# UNITED STATES PATENT AND TRADEMARK OFFICE

| APPLICATION NO. | FILING DATE | FIRST NAMED INVENTOR | ATTORNEY DOCKET NO. | CONFIRMATION NO. |
|-----------------|-------------|----------------------|---------------------|------------------|
| 10/527,237      | 09/22/2005  | Stefan Welle         | 29400-1             | 2839             |

| <b>Office Action Summary</b> | <b>Application No.</b><br>10/527,237 | <b>Applicant(s)</b><br>STEFAN WELLE |  |

(Field Figure 4)

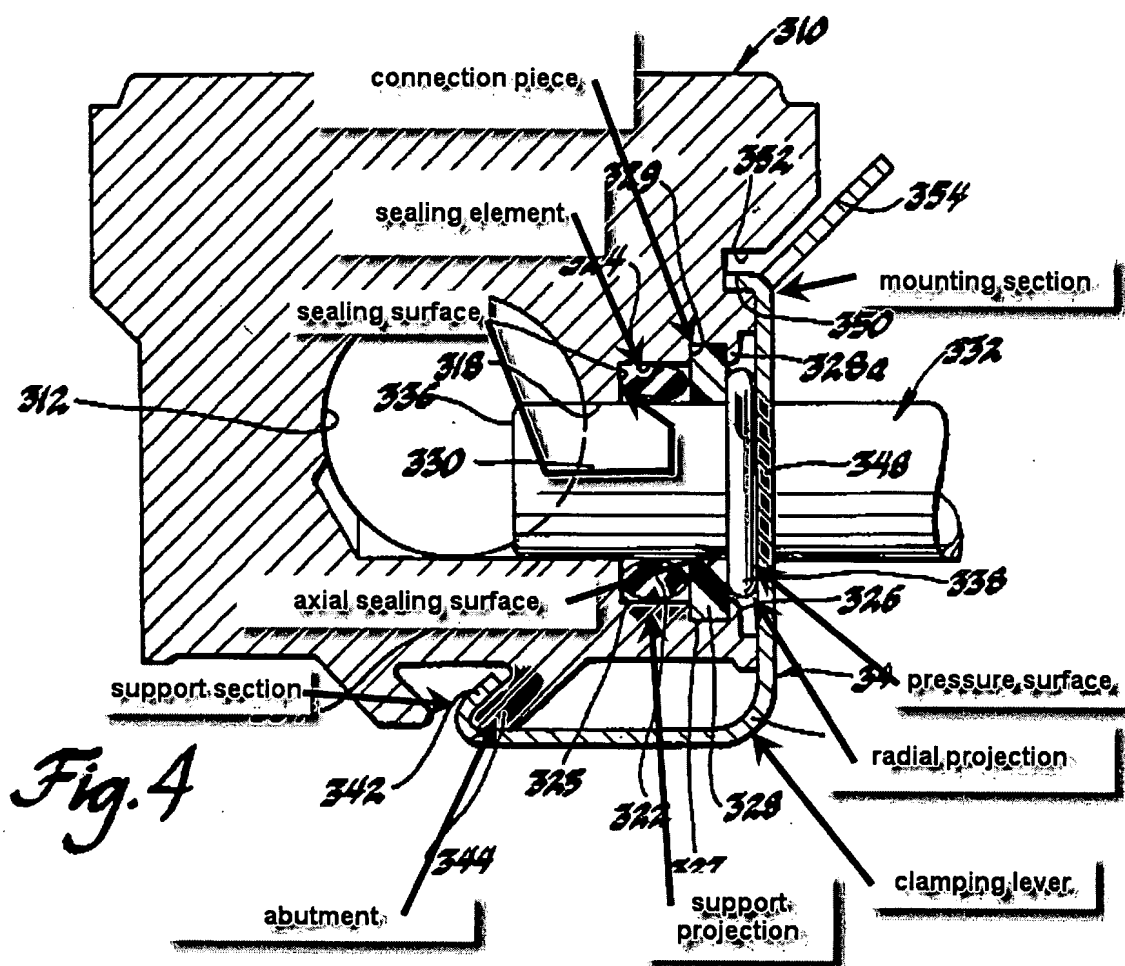
14. In regard to claim 1, Field discloses in Figure 4, below, a connection device, with a conduit end (the whole part of the conduit shown in Figure 4, below) associated with a fluid conduit and having a radial projection and an axial sealing surface, with a sealing element interposed between the axial sealing surface and a sealing surface, with a clamping lever having a support section for support on an abutment provided on the element, a pressure surface associated with the radial projection, and a mounting section with which the radial projection can be pressed against the element by means of a tensioning device.

15. In regard to claim 2, Field further discloses in Figure 4, above, a connection piece having a radial projection.

16. In regard to claim 3, Field discloses in Figure 4, above, a connection piece.

18. In regard to claim 4, Field discloses in Figure 4, above, a radial projection.

20. In regard to claim 5, Field discloses in Figure 4, above, a radial projection.

22. In regard to claim 6, Field further discloses in Figure 4, above, that the axial sealing surface is a plane surface (as observed, the surface appears to be planar).

23. In regard to claim 7, Field further discloses in Figure 4, above, that the axial sealing surface is adjacent a support projection.

24. In regard to claim 12, Field further discloses in Figure 4, above, that the fluid conduit extends through an opening of the clamping lever (column 4, lines 11-14).

25. In regard to claim 14, Field further discloses in Figure 4, above, that the opening has a discontinuous edge (the opening is made in the clamp lever by a pair of arms, therefore it is discontinuous; column 4, lines 11-14).

26. In regard to claim 15, Field further discloses in Figure 4, above, that the support section of the clamping lever and the abutment form a hinge (with the clamping lever disengaged at the mounting section, the support section will hinge about the abutment, therefore the support section of the clamping lever and the abutment form a hinge).

27. In regard to claim 17, Field further discloses in Figure 4, above, that the pressure surface is in central contact with the radial projection (as can be observed in Figure 4, above, the pressure surface in contact with the central region of the radial projection).

(Messerschmidt Figure 3)

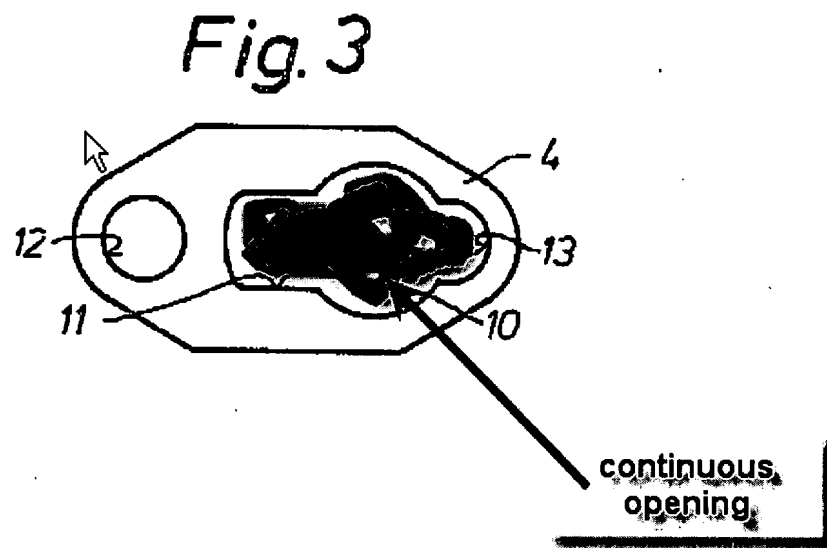
36. In regard to claim 13, Field discloses the claimed invention except for continuous edge opening in the clamping lever. Messerschmidt teaches a connection device clamping lever in Figure 3, below, with a continuous opening to secure a conduit to an element, e.g. to secure a fuel injection nozzle to an engine (column 1, lines 9-14). As Messerschmidt relates to connection devices with clamping levers, it would have been obvious to one having ordinary skill in the art at the time the invention was made to modify the lever of Field with the continuous opening as taught by Messerschmidt to secure a conduit to an element

(Schulz-Hausmann et al Figure 4)

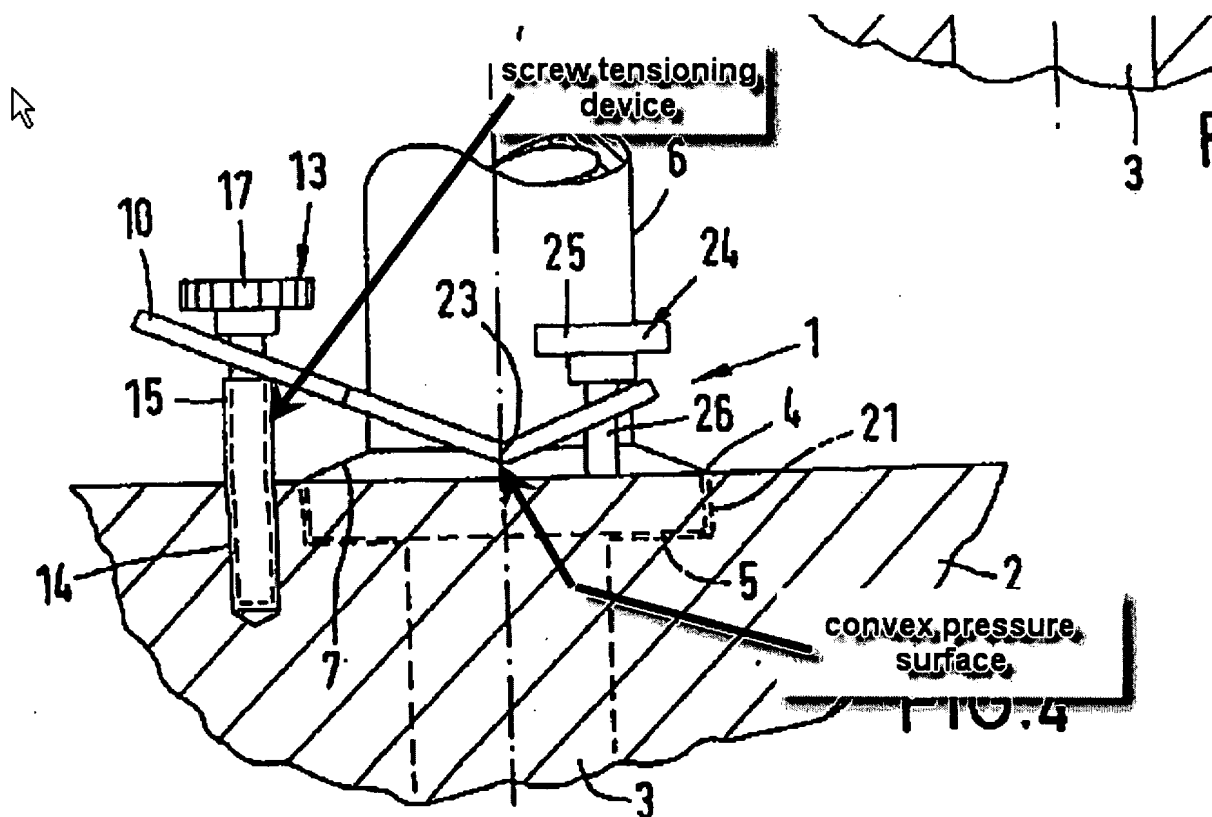
38. In regard to claim 16, Field discloses the claimed invention except for the convex surface of the pressure surface. Schulz-Hausmann et al teach a connection device with lever arms in Figure 4, below, with convex pressure surfaces to improve the ratio of the lever arms to influence

contact force (column 2, line 6, through column 3, line 3). As Schulz-Hausmann et al relate to connection devices with lever arms, it would have been obvious to one having ordinary skill in the art at the time the invention was made to modify the arms as disclosed by Field to have convex pressure surfaces as taught by Schulz-Hausmann et al to improve the ratio of the lever arms to influence contact force.

39. In regard to claim 18, Field discloses the claimed invention except for a screw tensioning device. Schulz-Hausmann et al further teach in Figure 4, above, a screw tensioning device to allow the adjustment of tension on the connection device arms (column 2, lines 49-56). As Schulz-Hausmann et al relate to connection devices with lever arms, it would have been obvious
